**ACCC Preliminary View
on Murraylink's Application for Conversion**

TransGrid's Submission to the ACCC

18 July 2003

ACCC's Preliminary View on Murraylink's Application for Conversion to Regulated Status

Figure A – Murraylink Losses

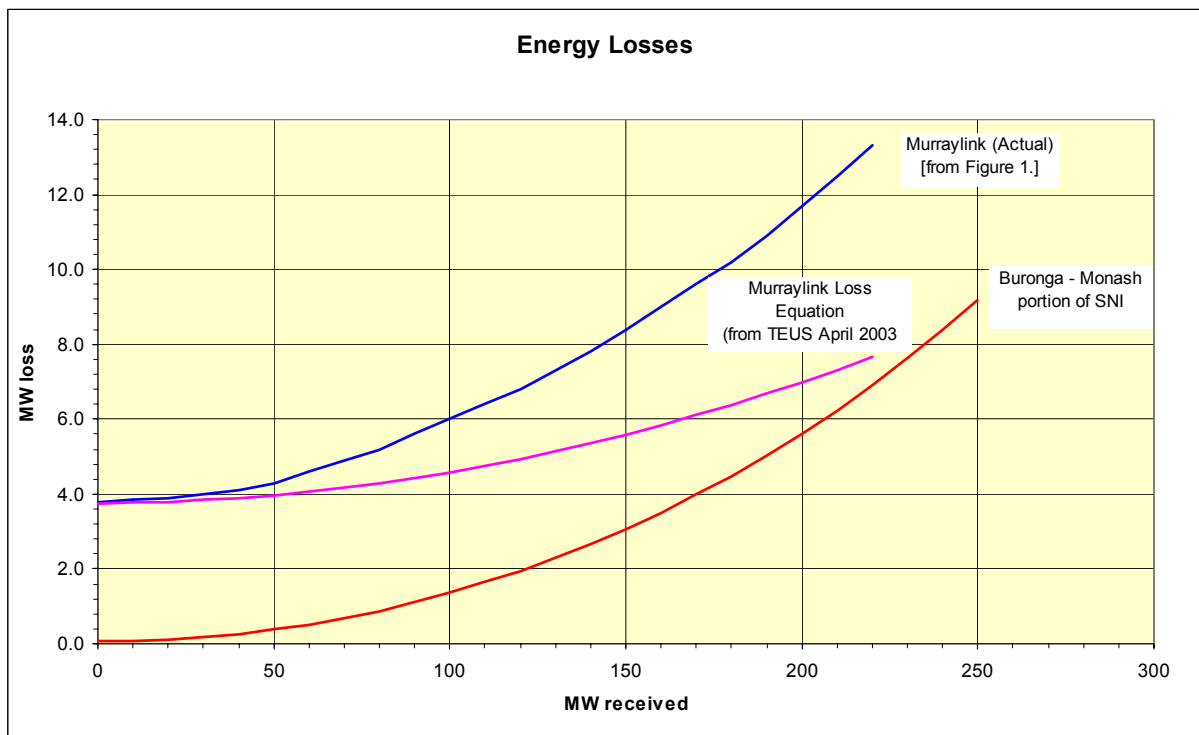
As can be seen from Figure A, Murraylink's actual losses are significantly higher than the losses assumed in the Market benefit calculations. Therefore, the calculated market benefits for Murraylink will be too high.

TransEnergieUS made an estimate of the losses in Alternative 3. Figure A below shows the estimated losses on the Buronga – Monash portion of SNI. It can also be seen that SNI has significantly lower losses than Murraylink across the whole range of power transfer capability. When Murraylink was operating as a MNSP, losses were part of Murraylink's operating costs. If Murraylink becomes a TNSP, these additional losses will eventually be paid for by consumers in the NEM.

Figure B – Murraylink flow for optimised losses

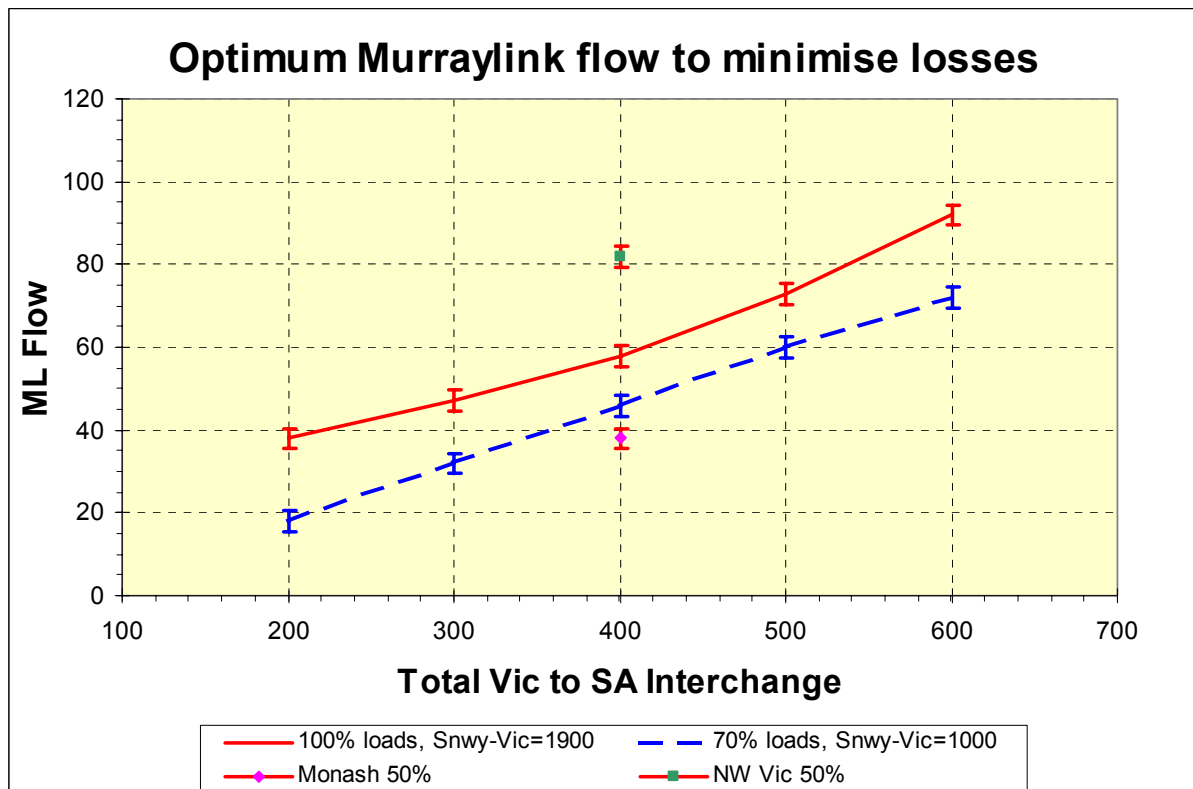
Figure B below shows the optimum flow on Murraylink that would minimise system losses for a given total interchange to SA for a given set of system conditions. The system conditions assumed for this study approximate peak summer load in SA and Vic with 1900MW import from NSW/ Snowy as well as 70% peak loads with 1000MW import from NSW/Snowy. Sensitivity checks were also done for Monash load at 50% and NW Vic load at 50%.

Figure B shows that while the optimum flow is sensitive to system conditions, the maximum flow on Murraylink is not likely to exceed 100 MW and more often than not will be much lower than this.

While it is accepted that once the Heywood interconnector reaches its limit, Murraylink can continue transferring additional power to SA, under normal circumstances (no constraints) Murraylink will carry very little power to SA. Calculation of Murraylink benefits needs to reflect this reduced effective capacity of Murraylink during normal times.
